Detroit  
Edison

Reference: Enrico Fermi Atomic Power Plant, Unit 2  
NRC Docket No. 50-341

Subject: Responses to Miscellaneous NRC Questions and Requests for Information.

Subject: Revised Suggested Responses to NRC Questions on  
Fermi Interim Plant Unique Analysis

SUPPRESSION CHAMBER COLUMN ANCHORAGE

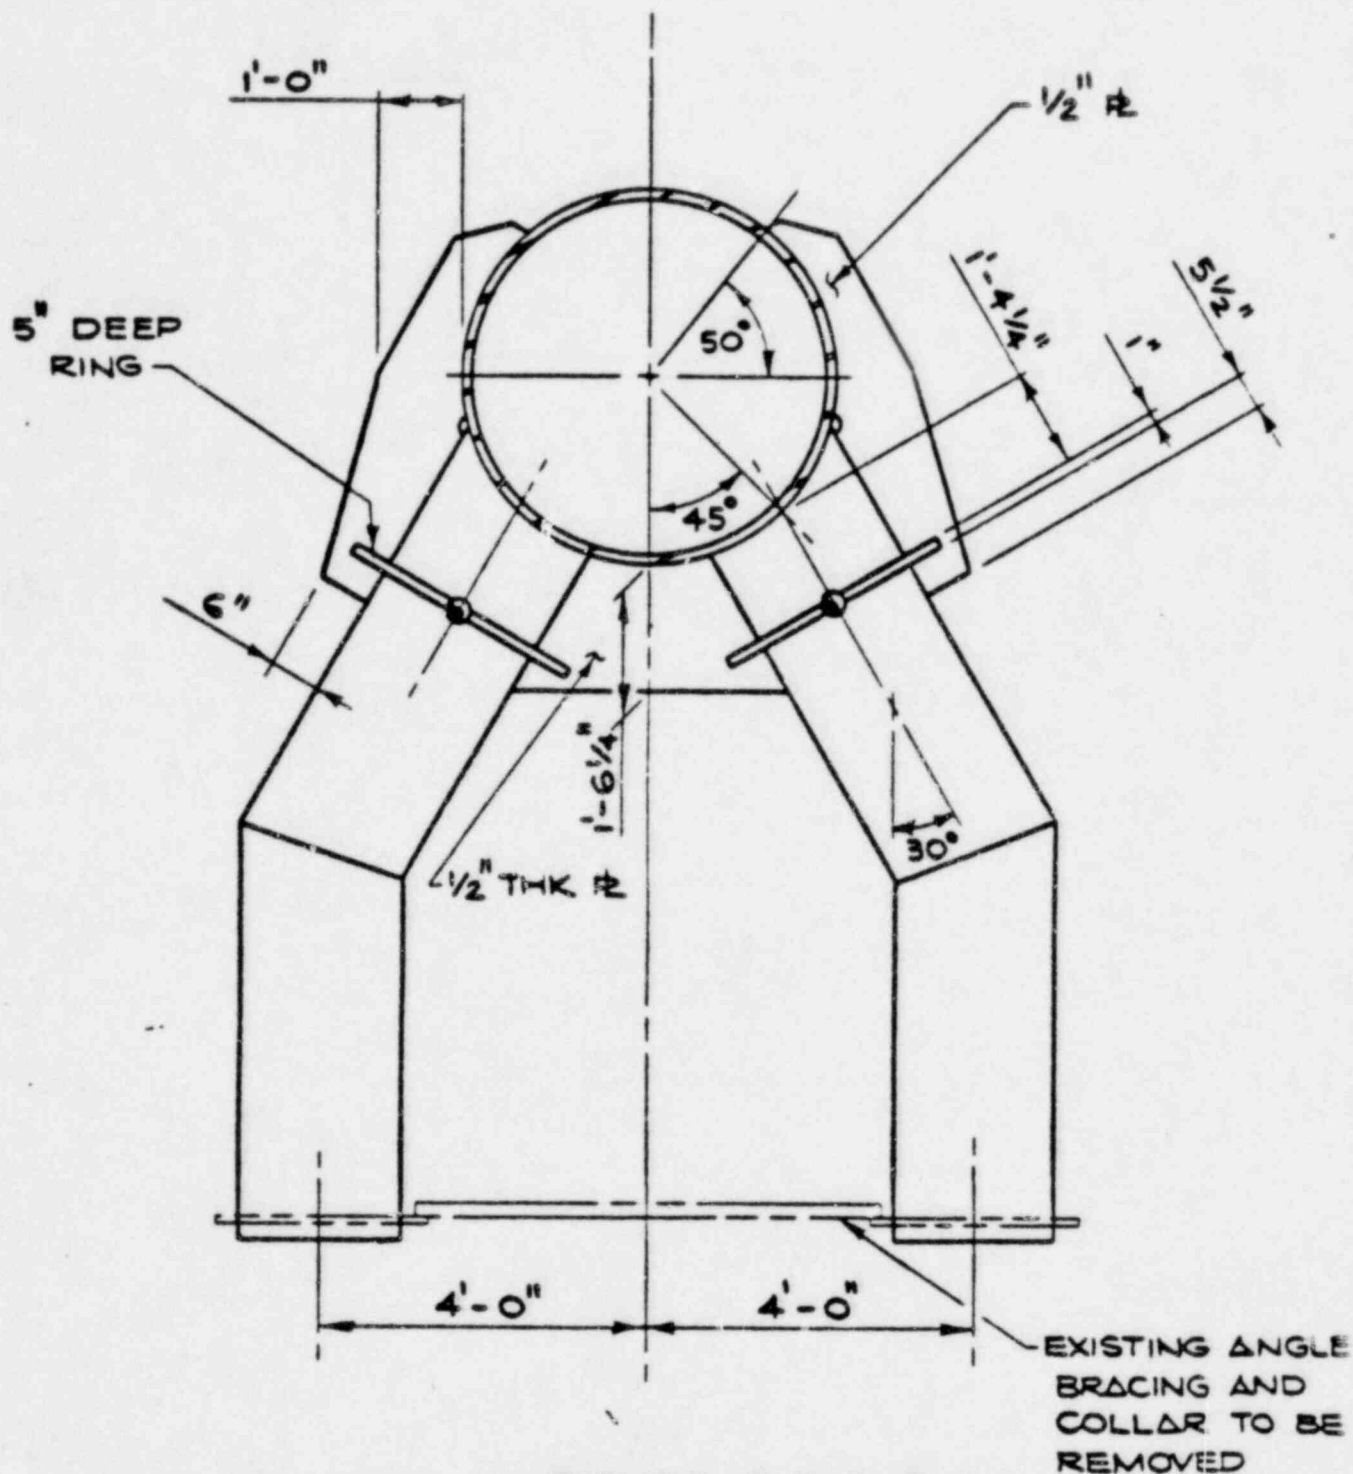
### 0 SUPPRESSION CHAMBER COLUMN ANCHORAGE (PAGE A.9)

THE FIGURE SHOWS THE SUPPRESSION CHAMBER UPLIFT RESTRAINT SYSTEM USED IN THE INTERIM PUA. THE RESTRAINT SYSTEM CONSISTS OF TWO PAIR OF TIE PLATES AT EACH COLUMN LOCATION CONNECTED TO BASE PLATES WITH SIX EPOXY GROUTED ANCHOR BOLTS. SINCE OVERSTRESSES WERE REPORTED IN THE INTERIM PUA FOR THE UPLIFT RESTRAINT SYSTEM AND SINCE THE PRELIMINARY ASSESSMENT OF C.O. LOADS SHOW THAT REACTIONS DUE TO C.O. LOADS EXCEED THE UPLIFT RESTRAINT SYSTEM ALLOWABLE CAPACITY, THE DECISION WAS MADE TO REPLACE THE UPLIFT RESTRAINT SYSTEM WITH A FULL MITERED JOINT SADDLE AND MODIFIED COLUMN HOLD-DOWN BASE PLATES.

### 0 PRELIMINARY MITERED JOINT SADDLE DESIGN (PAGE A.10)

JOINT SADDLE AND MODIFIED COLUMN HOLD-DOWN BASE PLATES. THE FIGURE IS NOT UP TO DATE IN THAT TWELVE AND NOT EIGHT ANCHOR BOLTS ARE BEING INSTALLED AT EACH SADDLE BASE PLATE LOCATION, AND SIX AND NOT FOUR ANCHOR BOLTS ARE BEING INSTALLED AT EACH COLUMN HOLD-DOWN BASE PLATE. THE MITERED JOINT SADDLE IS CONTINUOUS WITH THE COLUMN CONNECTION WEB PLATE AND PROVIDES A MEANS OF MORE EVENLY DISTRIBUTING LOADS, AND REDUCING STRESS CONCENTRATIONS, I.E., LOCAL STRESSES IN THE SHELL NEAR THE COLUMN CONNECTION ARE EXPECTED TO BE LESS.

FIGURE 3.2.2-5  
DOWNCOMER TRUSS

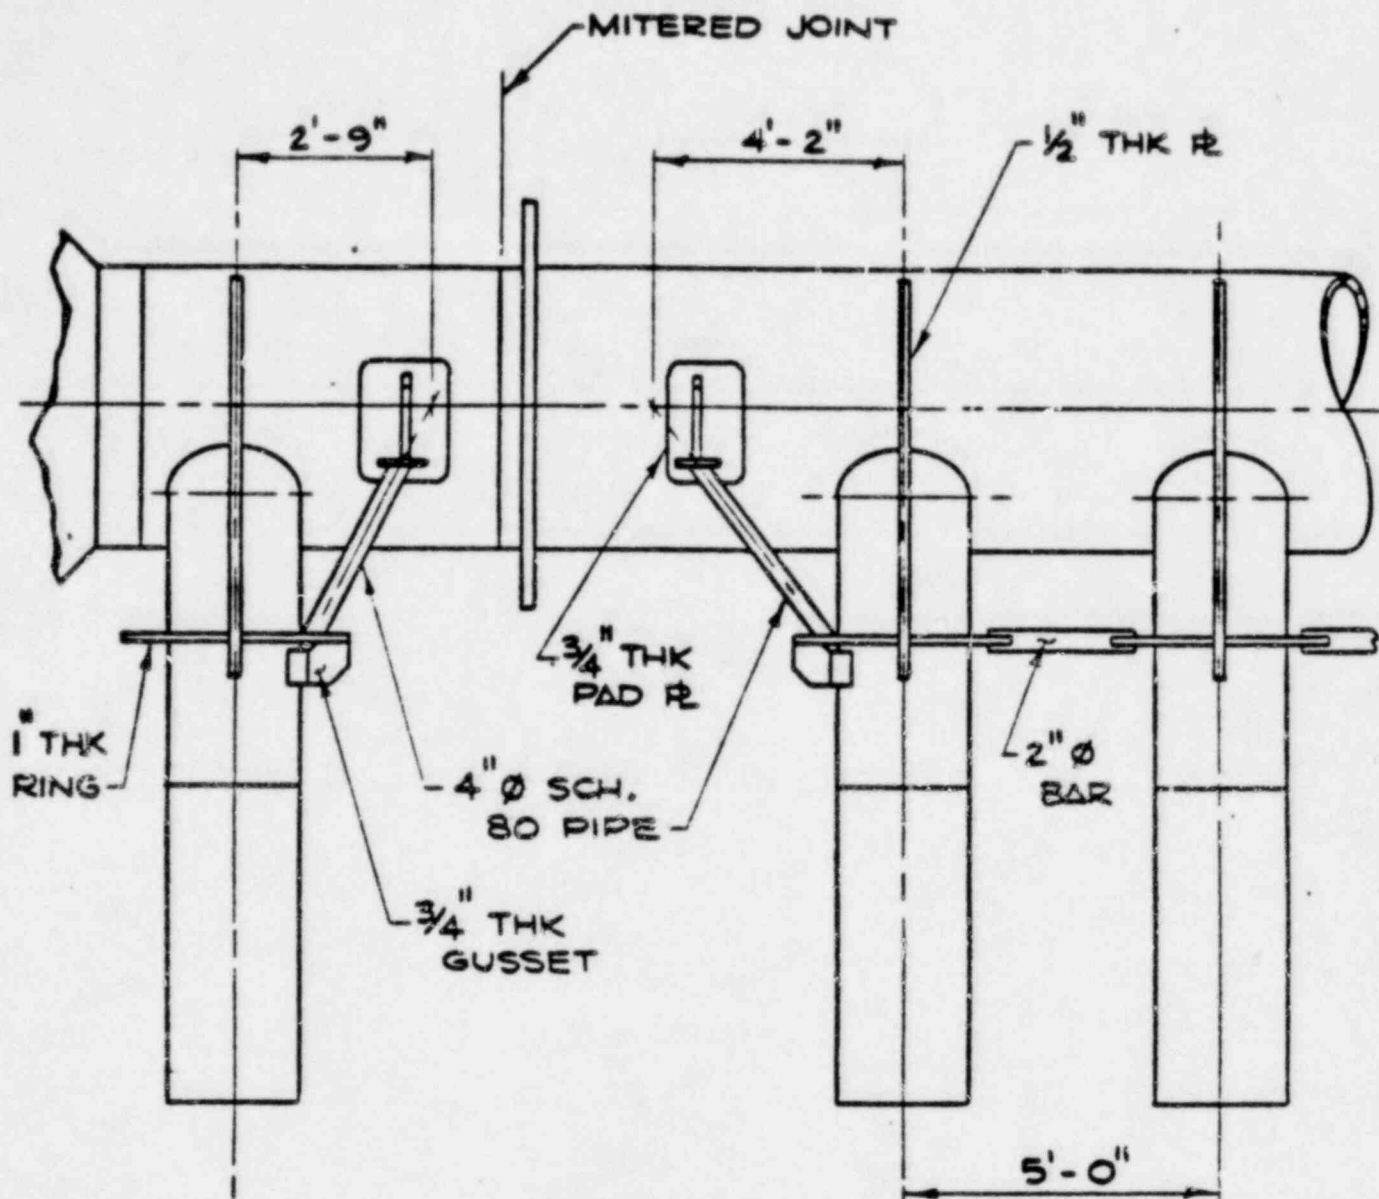
### 0 DOWNCOMER TRUSS (PAGE A.12)

THE FIGURE SHOWS THE DOWNCOMER TRUSS SYSTEM WHICH HAS BEEN ADDED TO THE FERMI VENT SYSTEM. THE PRINCIPLE ELEMENTS OF THE TRUSS SYSTEM INCLUDE BARS WHICH JOIN THE DOWNCOMER STIFFENING RINGS

OF ADJACENT DOWNCOMER PAIRS, AND PIPE MEMBERS WHICH CONNECT THE DOWNCOMER STIFFENING RINGS TO PAD PLATES ON THE VENT HEADER. THE DOWNCOMER TRUSS SYSTEM PROVIDES AN EFFICIENT MECHANISM FOR TRANSFERRING LOADS WHICH ACT NORMAL TO THE PLANE OF A DOWNCOMER PAIR. THE TRUSS SYSTEM ALSO PROVIDES ADDITIONAL OVERALL STIFFENING OF THE DOWNCOMER TO VENT HEADER INTERSECTION.

FERMI II - 1/32 SEGMENT MODEL  
INTERIM DESIGN SUPPORT SYSTEM

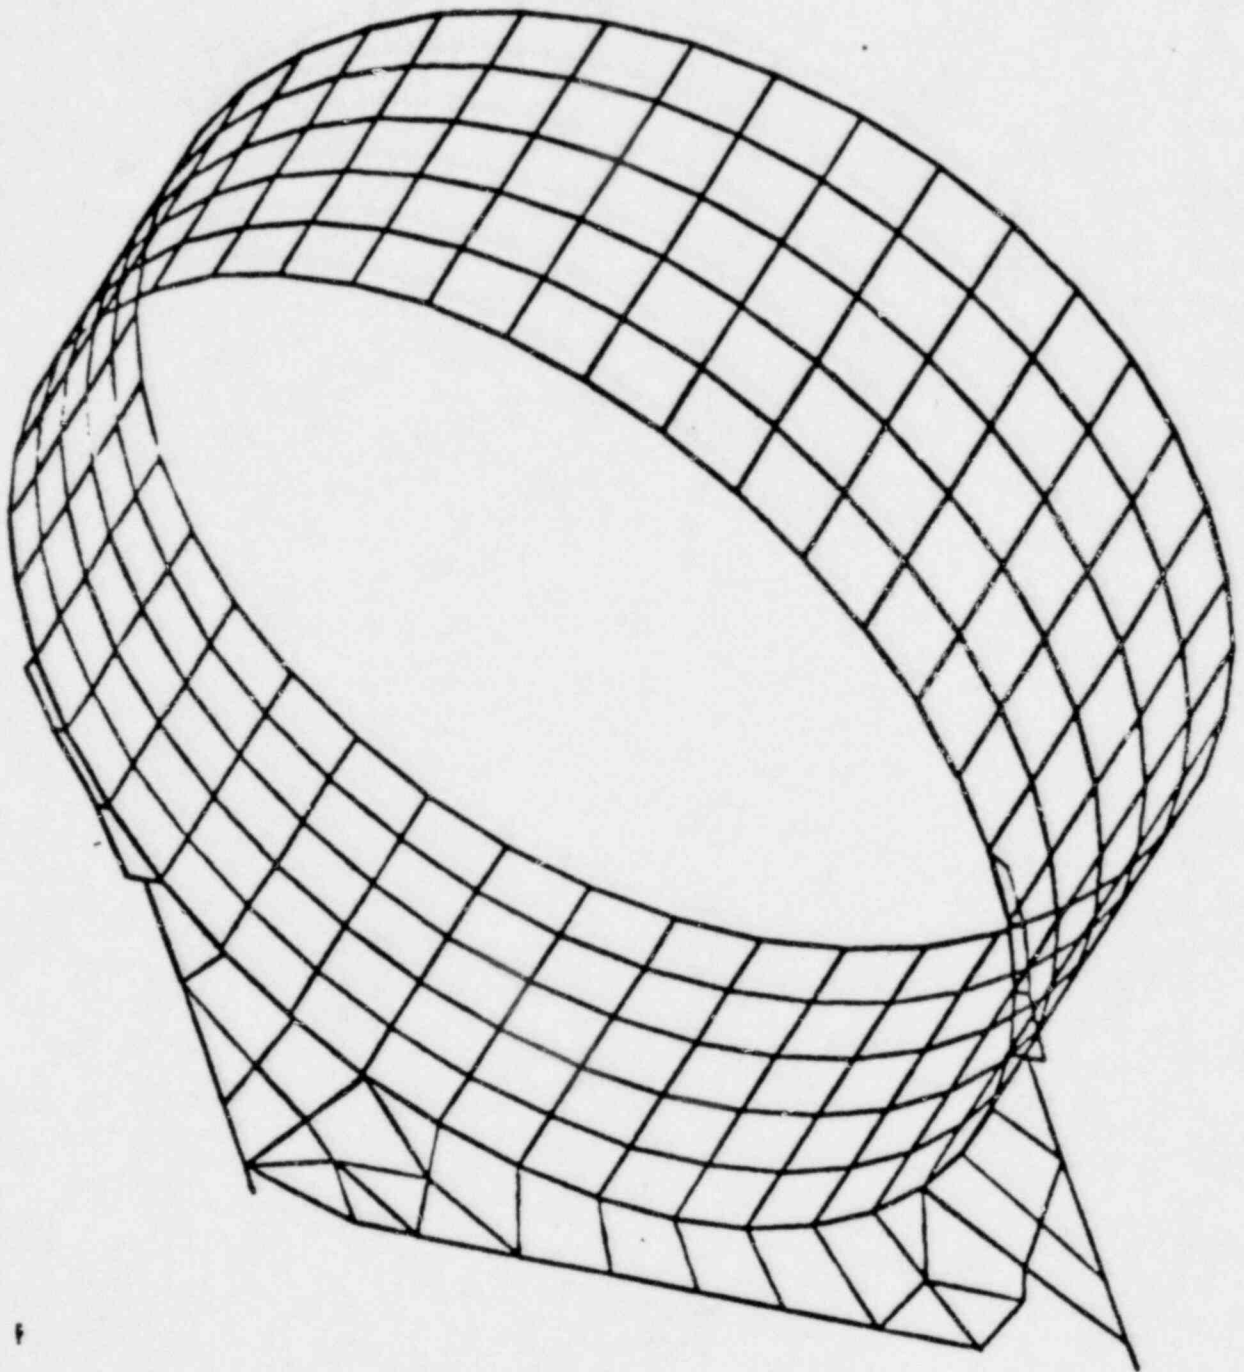
### 0 FERMII - 1/32 SEGMENT MODEL INTERIM DESIGN SUPPORT SYSTEM (PAGE A.17)

FIGURE SHOWS ANALYTICAL MODEL WHICH WAS USED IN THE PRELIMINARY ASSESSMENT OF C.O. LOADS FOR THE FERMII SUPPRESSION CHAMBER WITH THE SUPPORT SYSTEM USED IN THE INTERIM PUA. THE MODEL IS SUITABLE FOR DETERMINING THE OVERALL RESPONSE OF THE SUPPRESSION CHAMBER AND IS USED TO COMPUTE SUPPORT REACTIONS.

FERNI II - 1/32 SEGMENT MODEL

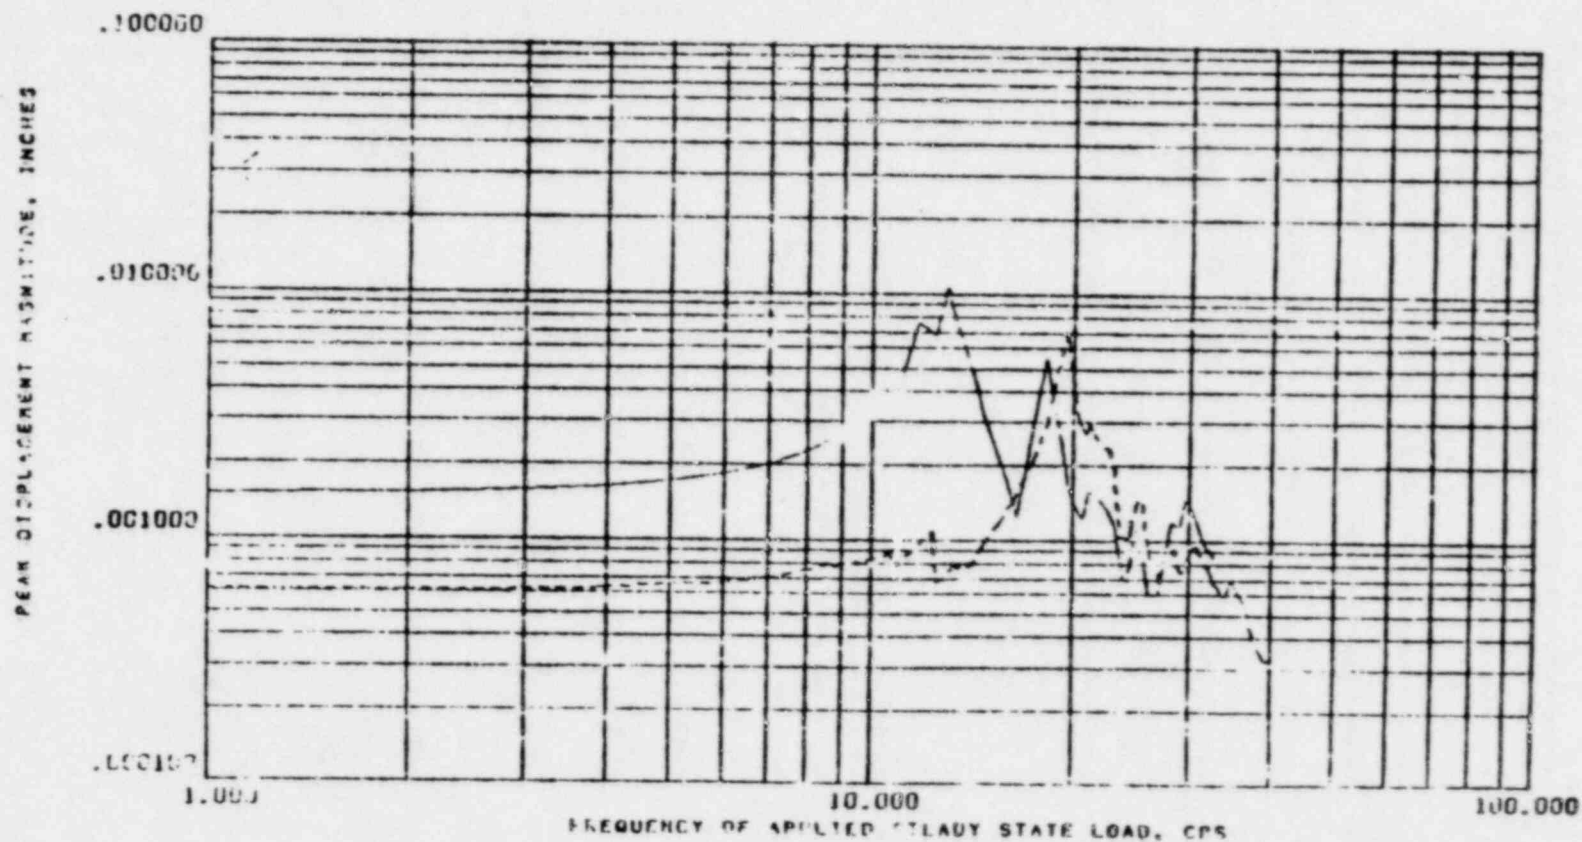
### 0 FERMII - 1/32 SEGMENT MODEL MITERED JOINT SADDLE STRUCTURE (PAGE A.18)

FIGURE SHOWS ANALYTICAL MODEL WHICH WAS USED IN THE PRELIMINARY ASSESSMENT OF C.O. LOADS FOR THE FERMII SUPPRESSION CHAMBER WITH MITERED JOINT SADDLES. THE MODEL IS SUITABLE FOR DETERMINING THE OVERALL RESPONSE OF THE SUPPRESSION CHAMBER AND IS USED TO COMPUTE SUPPORT REACTIONS.

ENRICO FERMI NUCLEAR GENERATING PLANT  
STEADY STATE STRUCTURAL RESPONSE  
FOR 1 PSI CONDENSATION OSCILLATION LOADING  
TOP OF OUTSIDE COLUMN (NODE 290) VERTICAL DISPLACEMENT

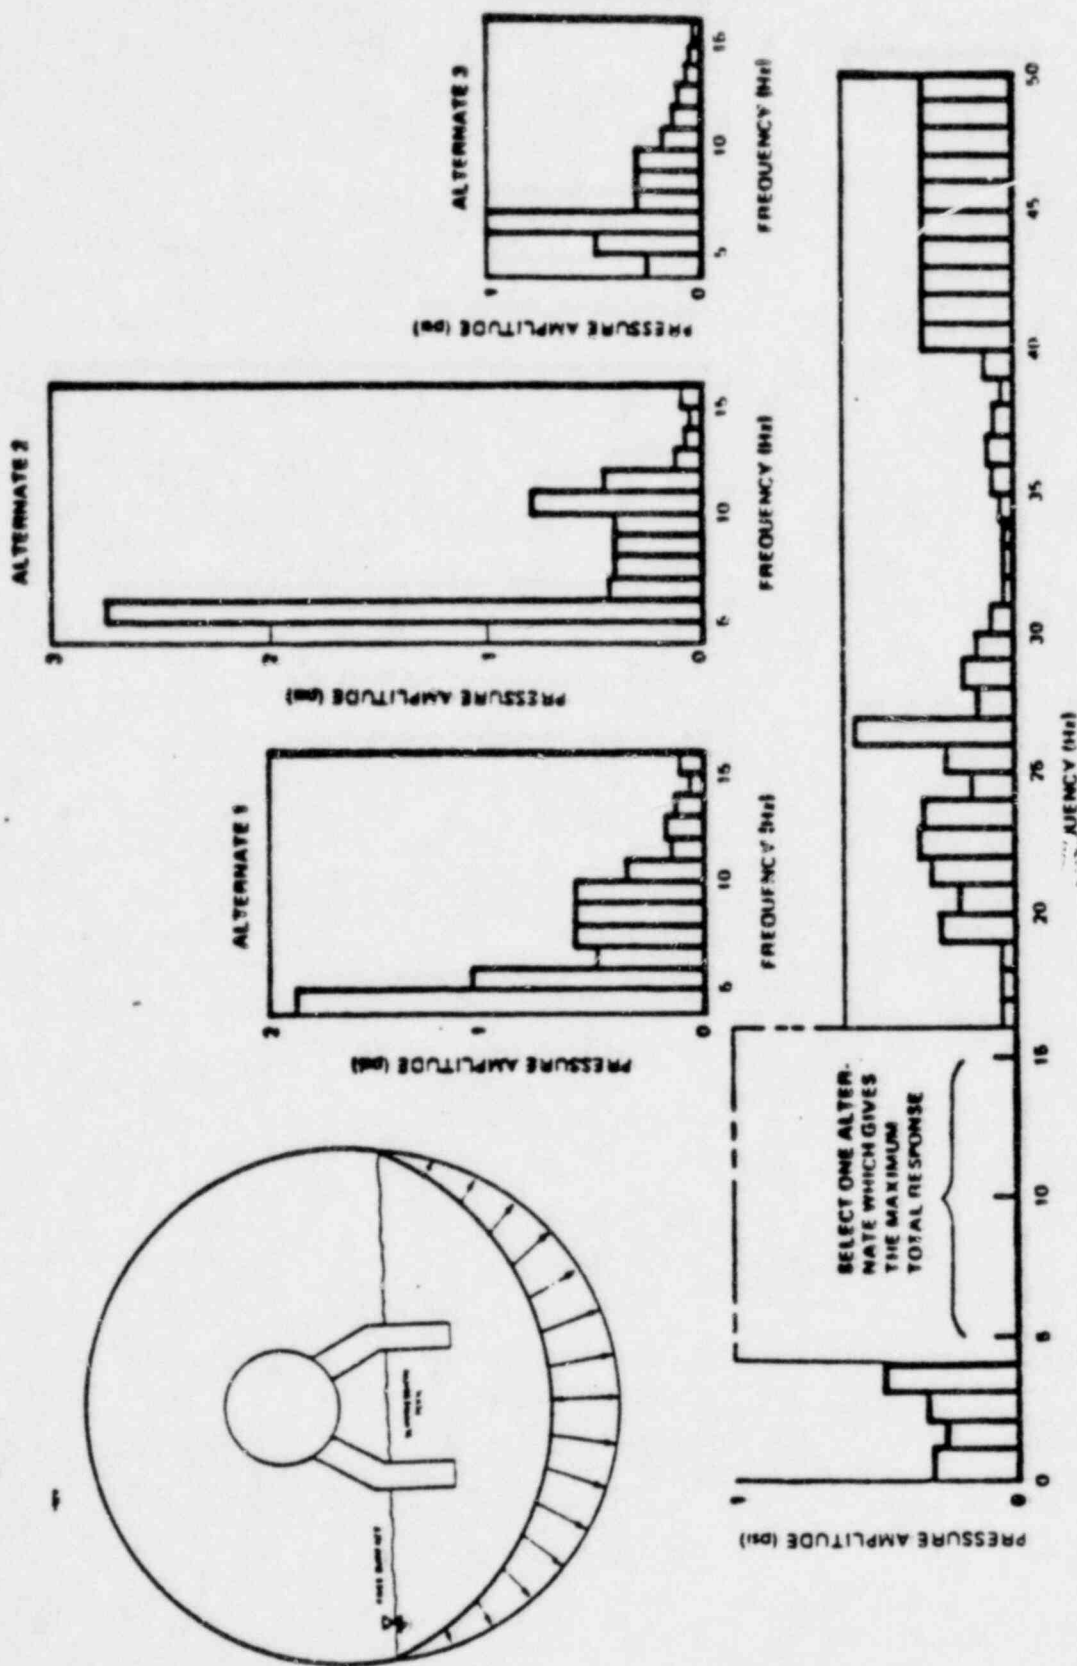
### 0 ENRICO FERMII NUCLEAR GENERATING PLANT STEADY STATE STRUCTURAL RESPONSE (PAGE A.19)

THE FIGURE SHOWS THE STEADY STATE RESPONSE OF THE SUPPRESSION CHAMBER OUTSIDE COLUMN DUE TO A NORMALIZED C.O. LOADING FOR THE SUPPRESSION CHAMBER WITH THE INTERIM PUA SUPPORT SYSTEM AND THE SADDLE SUPPORT SYSTEMS. THE PLOTS SHOW VERTICAL DISPLACEMENTS AT THE TOP OF THE COLUMN AND CAN BE INTERPRETED AS COLUMN AXIAL FORCE IF MULTIPLIED BY  $AE/L$ . THE PLOTS SHOW THAT THE DOMINANT SUPPRESSION CHAMBER FREQUENCY IS INCREASED FROM ABOUT 12HZ TO ABOUT 19HZ WITH THE ADDITION OF A MITERED JOINT SADDLE.

THE PLOTS ALSO SHOW THAT THE AMPLITUDES (COLUMN LOADS) ARE REDUCED BY 45% IN THE RANGE OF THE C.O. LOAD FREQUENCIES WITH THE HIGHEST AMPLITUDES (5-10HZ).

FIGURE 2  
VENT HEADER DEFLECTOR MODIFICATION

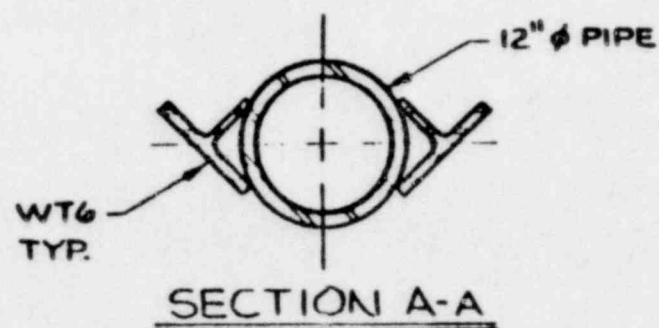
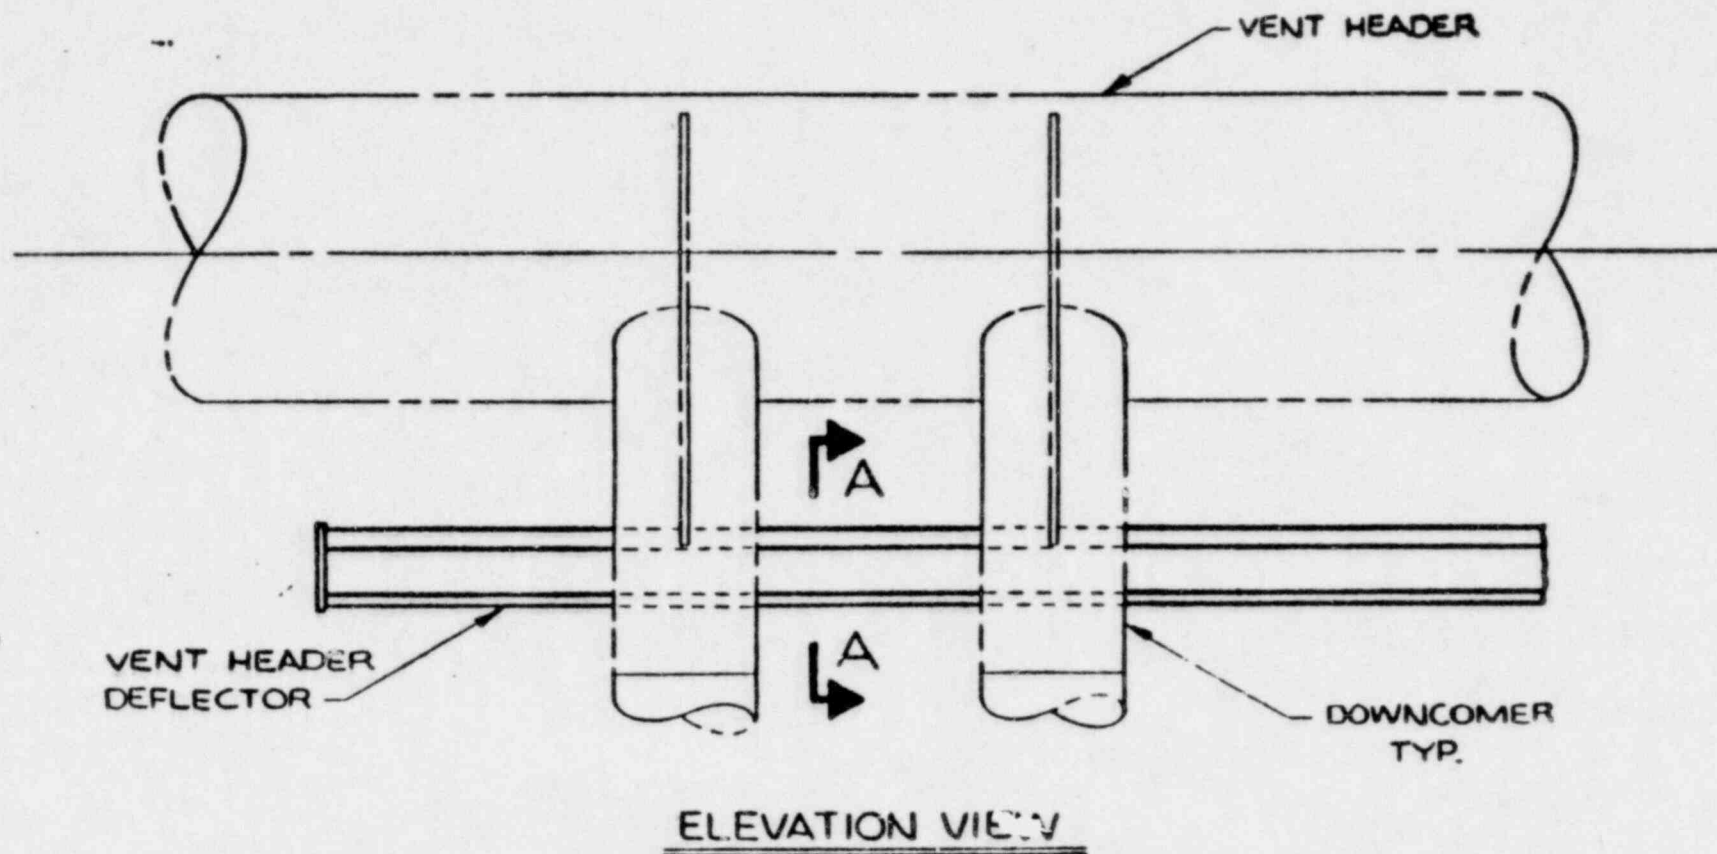
0 VENT HEADER DEFLECTOR MODIFICATION (PAGE B.5)

THE FIGURE SHOWS THE VENT HEADER DEFLECTOR WHICH HAS BEEN ADDED TO THE FERMI VENT SYSTEM SINCE THE INTERIM PUA WAS COMPLETED. THE DEFLECTOR CONSISTS OF A 12 IN. DIAMETER PIPE WITH A 6 IN. TEE WELDED ON EACH SIDE. THE HORIZONTAL PROJECTED WIDTH OF THE DEFLECTOR IS ABOUT 26 IN. THE DEFLECTOR IS SUPPORTED BETWEEN THE DOWN-COMERS BELOW THE VENT HEADER BY THE CROTCH PLATES AS SHOWN ON PAGE A.11.
